Service Bulletin No. 062

Alternator Models ALU, ALX & ALY Series HET P/N ALA-0020G Through Bolt Replacement

Figure 1 - ALX-8521LS Pan-Head Through Bolt Head Separation Example Shown with Fan Removed.

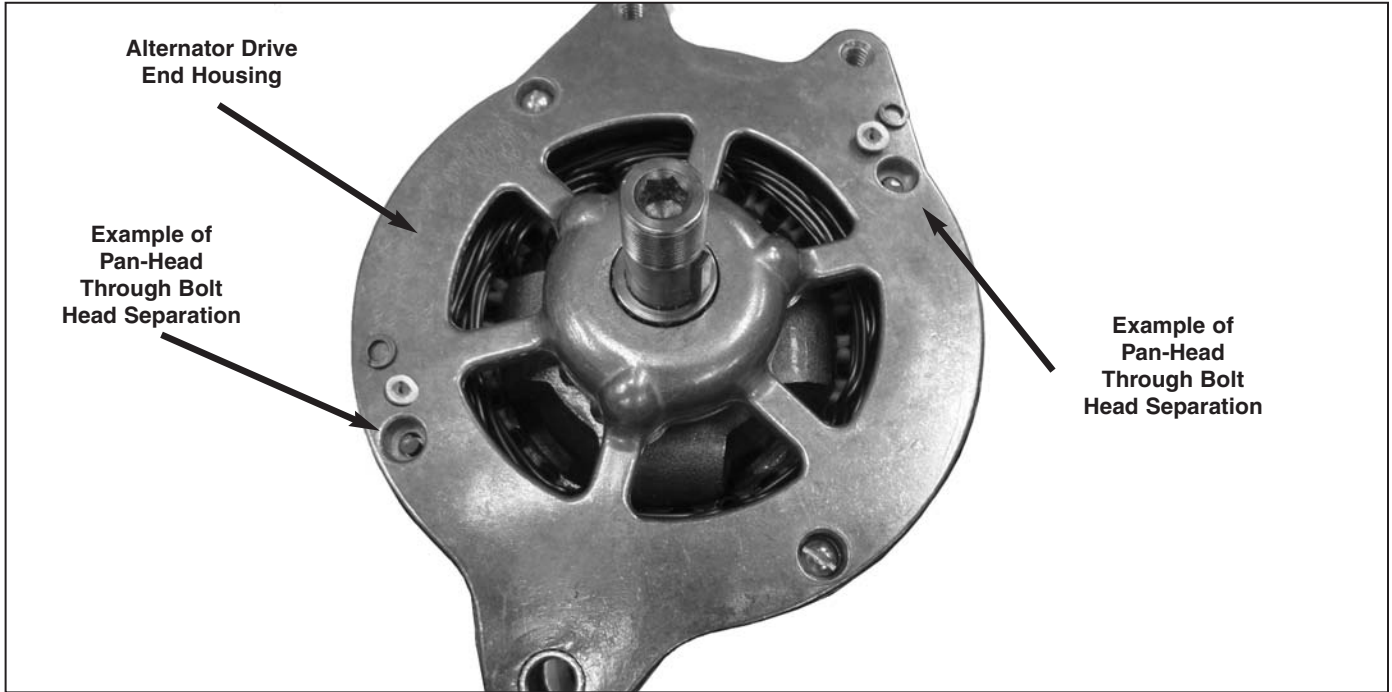
- (1) Affected serial numbers of alternator model ALU, ALX, and ALY may have a pan-head style HET P/N ALA-0020G through bolt installed. These pan-head through bolts have had incidences of bolt head separation. Refer to Figure 1.
- (2) To eliminate the risk of through bolt head separation, all pan-head through bolts must be replaced with HET P/N ALA-0020G fillister-head style through bolts on the affected alternators. Refer to Figure 2 and Figure 3.
- (3) The pan-head version of the HET P/N ALA-0020G through bolt is being discontinued and will no longer be used.
- (4) Regulatory action is unknown.

Figure 2 - Pan-Head Through Bolt (If found alternator must be repaired)

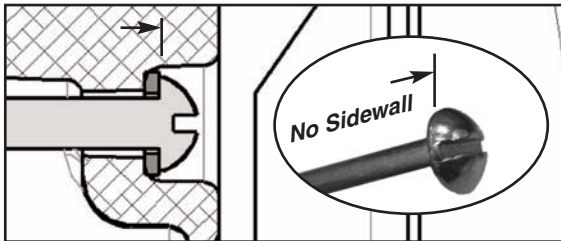
- a. If a pan-head through bolt is installed, return the affected alternator to HET for repair per 3.C Corrective Action. Refer to Figure 2.
 - b. If positive identification that four fillister-head through bolts are installed, the affected alternator is in compliance with this service bulletin. Proceed to 3.D(3), Return to Service. Refer to Figure 3.

Figure 4 - Through Bolt Head Inspection Example Shown.

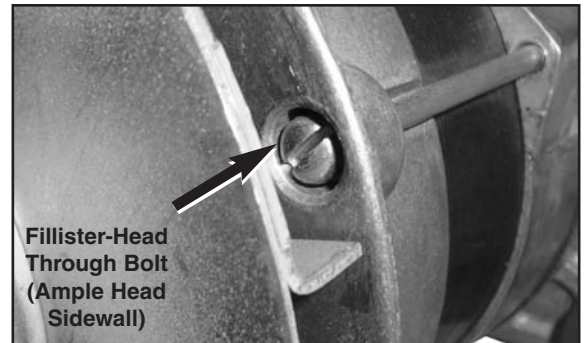
- B. Inspection:
 - (1) Using a bright white light, inspect the alternator drive end housing at each through bolt location (four each) beneath the fan. Refer to Figure 4.
